CERTIFICATE OF APPROPRIATENESS

Property: 1115 E. 11th Street, in the Norhill historic district. The property is a ____SF vacant commercial lot.

Proposal: Alteration – The applicant is proposing the remodel of an existing commercial building (restaurant).

FRONT SOUTH ELEVATION

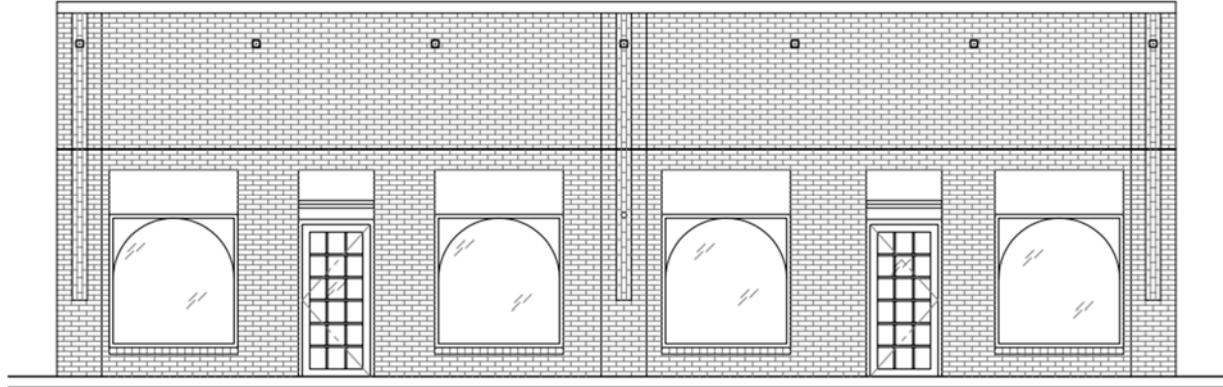
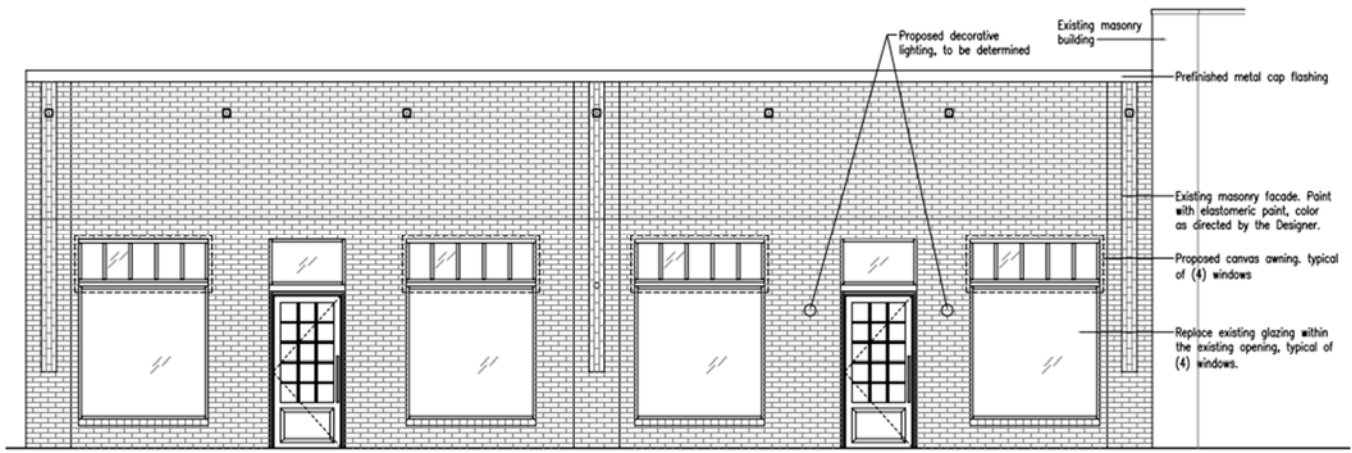
**** All windows should be wood windows ****

Transom windows will be allowed if it can be proven that they were a part of the original contributing structure.
